TECHNICAL MEMORANDUM

Subject: 2619-2623 Wisconsin Avenue NW – Response to Team Deliverables

Figure 1: On-Street Parking Spaces Available – Weekday Afternoon (in response to Comment #1)

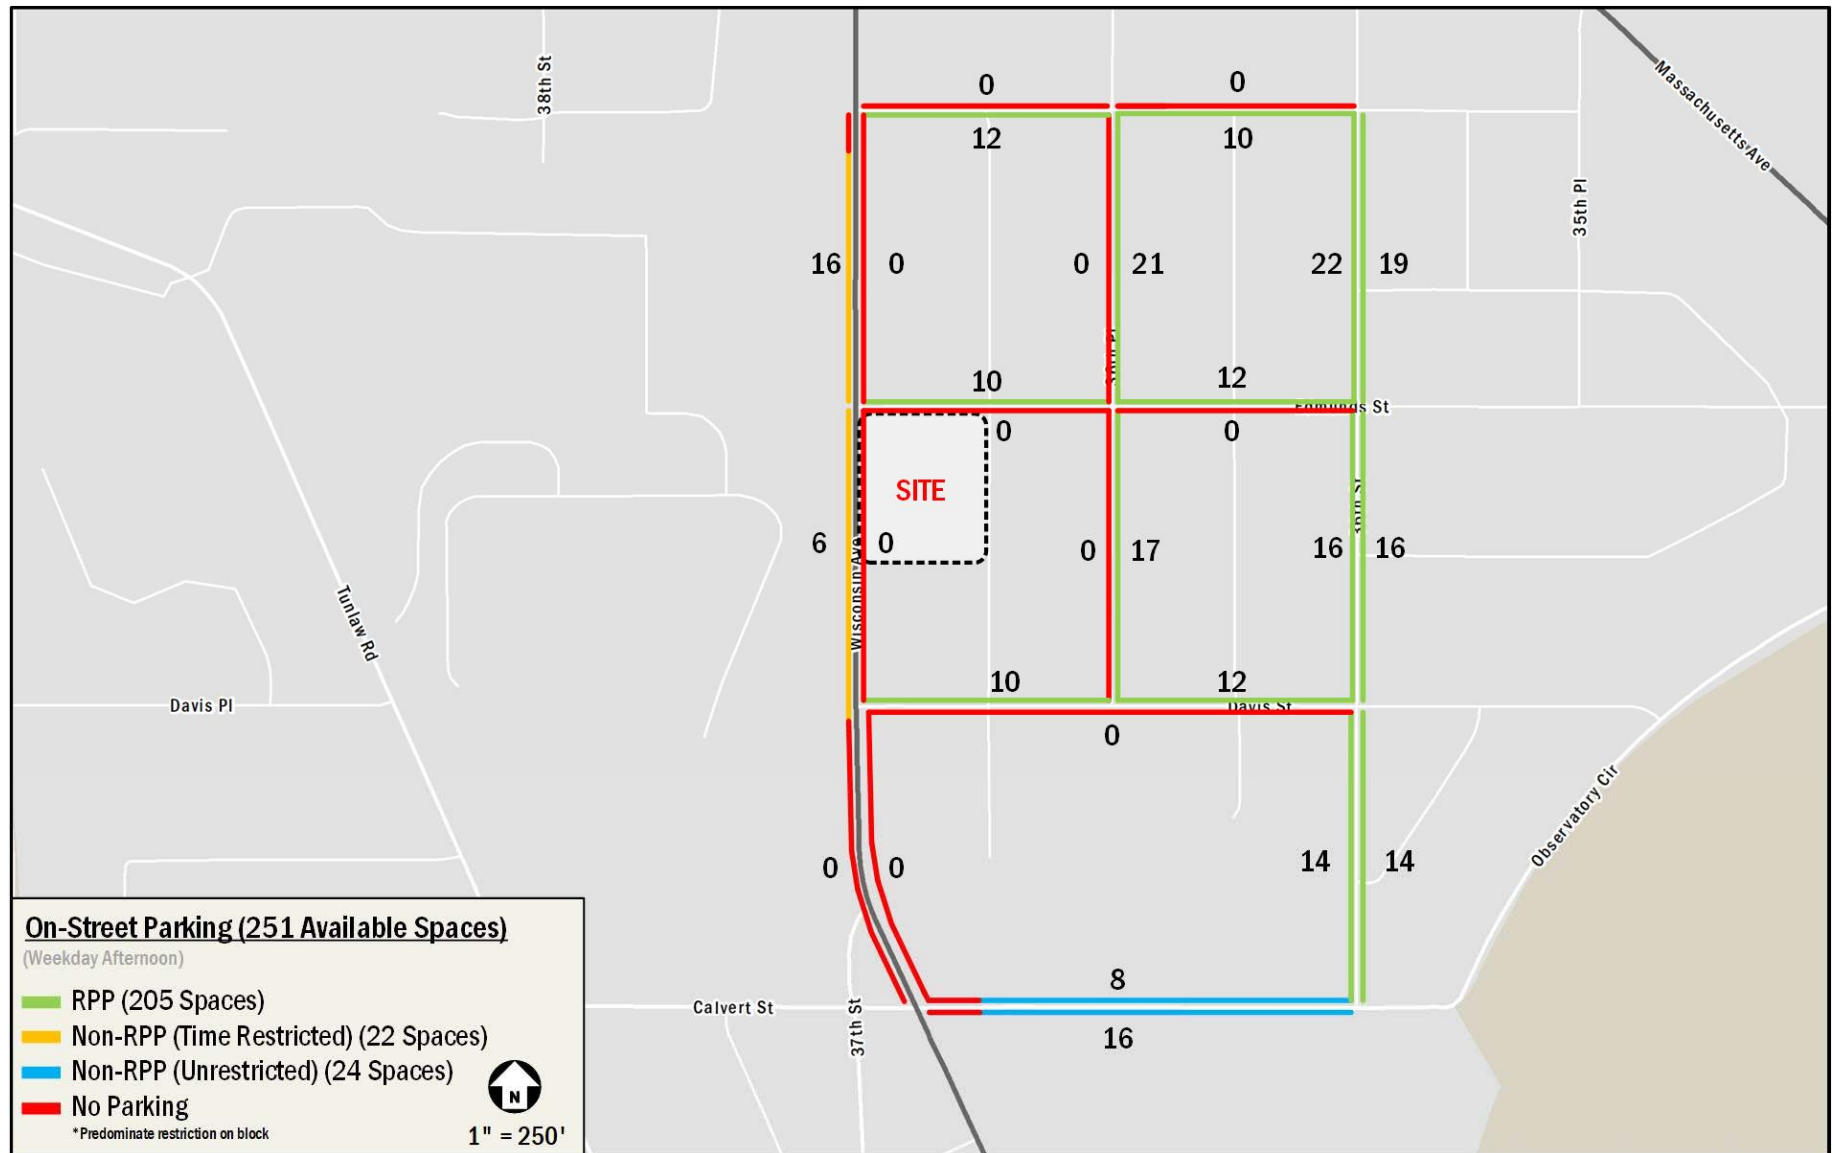
1. *Highlight non-RPP spaces in parking study to address staff parking concerns.*

Response: Please see Figure 1 which identifies the number of non-RPP spaces (46) in the parking study area during the weekday peak hour with highest parking demand. These spaces consist of 22 spaces on the west side of Wisconsin Avenue and 24 spaces on both sides of Calvert Street between Wisconsin Avenue and 36th Street.
